The 10-Minute Cooling Curve

***A Distribution Transformer
Manufacturer's Perspective***

HV Hot Resistance Curve

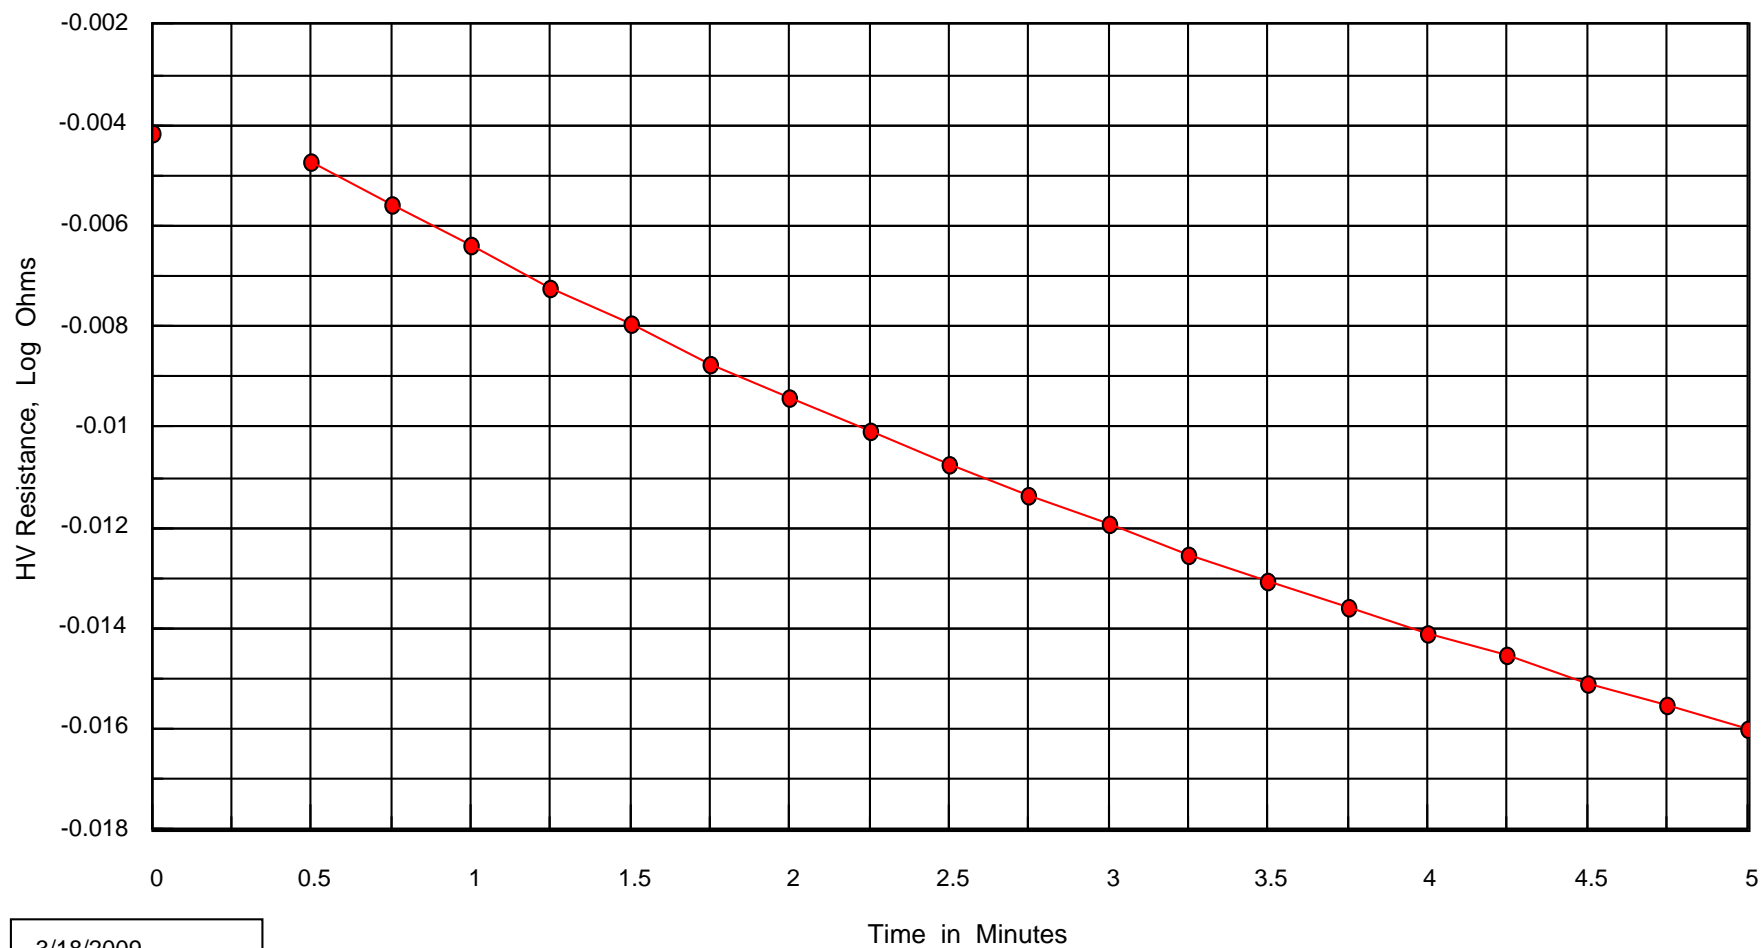
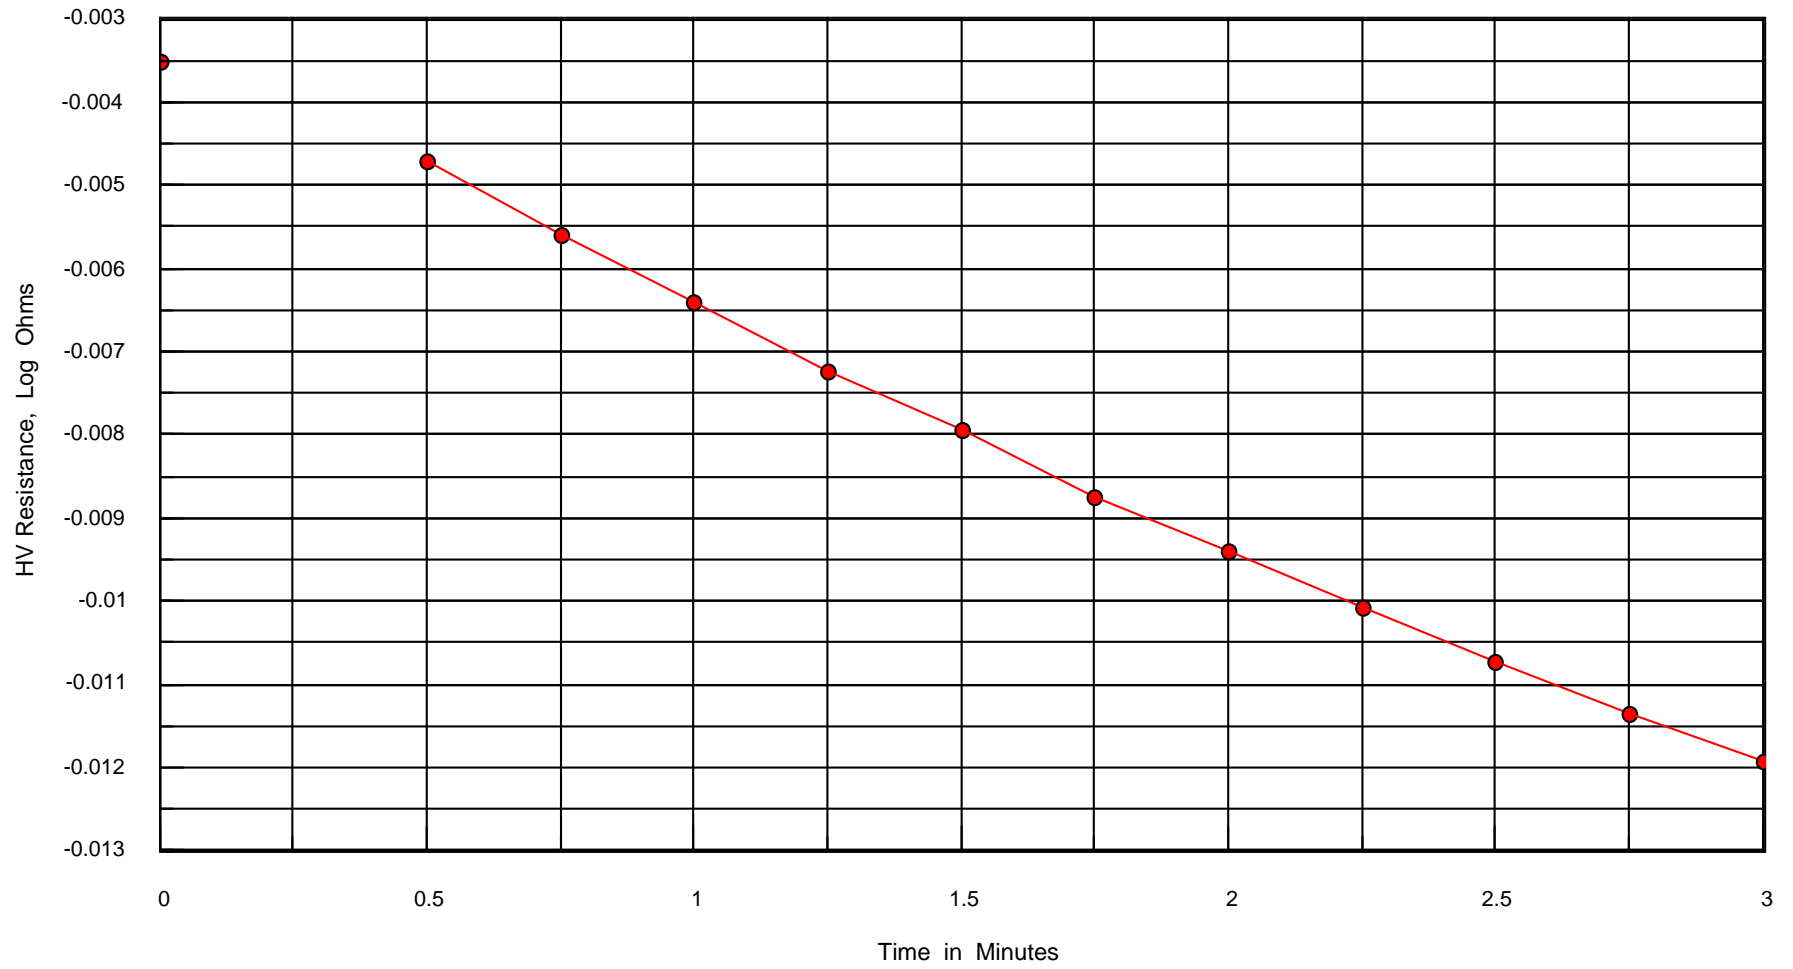
- From the 10-minute graph it is easy to see the decreasing slope of the curve as time progresses farther from the instant of shutdown.
- Since the coils are of small mass (compared to power transformer coils), the winding temperature rapidly approaches the surrounding oil temperature, and then the release rate declines as this temperature differential is reduced. This is seen by the flattening out of the curve.

- Performing regression analysis on the entire 10-minutes of data can result in the flat portion of the curve significantly influencing the time zero intercept.
- The curve slope is much greater in the first time interval (0 – 3 minutes), which we believe most accurately reflects the winding temperature decay, and hence leads to the most accurate projection of the “time zero” value.

- Requiring the manufacturers of small transformers to utilize a 10-minute cooling curve for temperature rise tests will produce less accurate results.
- We recommend, for the distribution class transformers, that it is more appropriate to specify a minimum number of points (suggest 10 points) collected over a certain time interval (suggest no longer than 30-second intervals).
